INDESIT company

Model type:
DB1IT

Commercial code:
F027941

Notices

N1045072FIG1

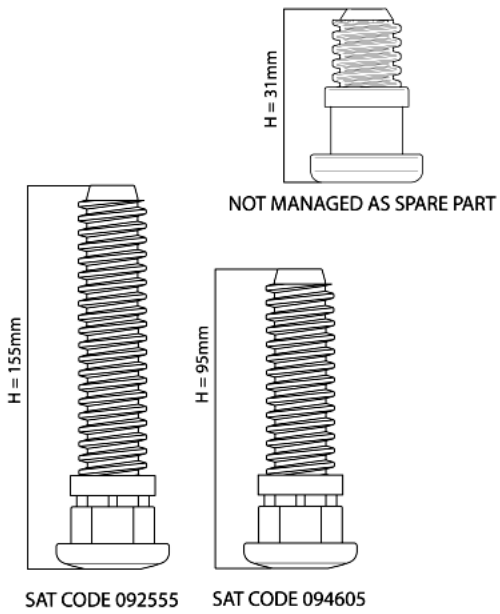
N1045072: Introduction of fixed rear foot H=31mm on free-standing models.

From serial no. 40218.0001, free-standing dishwashers affected by this modification have been equipped with new fixed rear feet (H=31mm).
The new foot replaces the adjustable one (H=155mm) Service code 092555; on the EVO3 range with TurboDry the new foot replaces the adjustable foot (H=95mm) Service code 094605.
The Spare Part Warehouse will continue to manage only 155mm and 95mm adjustable feet as they are interchangeable with the fixed 31mm foot.
The three feet are shown in illustration N1045072FIG1.

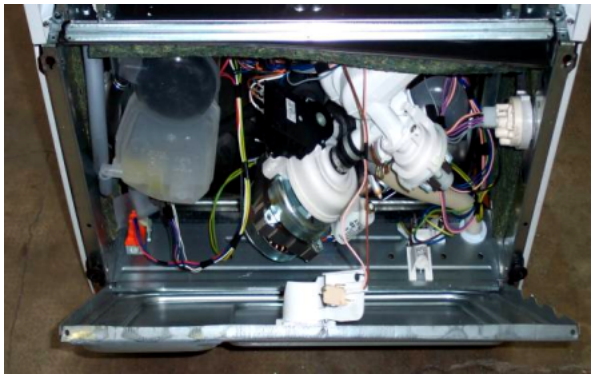
n1045062: Introduction of a new DW EVO structure

From serial number 30101.0001, all dishwasher models affected by this modification have been produced with EVO structure.
These models have been equipped with NEW TRAYS AND NEW FEET (see N1045062TAB1).

Photo N1045062FIG1 illustrates the bottom of the dishwasher with EVO structure.

Regulation assembly DX/SX Sat codes 078397 and 078396 will be managed up to stock end, after that they will be replaced by new Sat codes 092821 and092820. The same is for rear foot Sat code 078385 which will be replaced by Sat code 092822.

N1045063

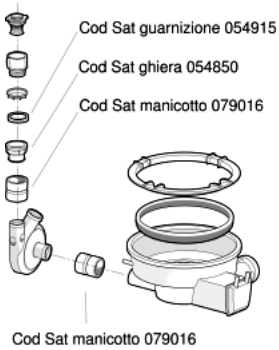
n1045063: Introduction of coupling+ring nut Sat code 093752

From serial number 30224.0001, all dishwashers affected by this modification have been equipped with the new coupling+ring nut assembly Sat code 093752, in place of coupling Sat code 079016, ring nut Sat code 054850 and gasket Sat code 054915.

Ring nut Sat code 054850 will continue to be available from the spare parts warehouse while stocks last, and coupling Sat code 079016 will continue to be stocked because it is still used for the tank-volute connection.
Picture N1045063 illustrates the premodification structure in FIG1 and the new structure in FIG2.
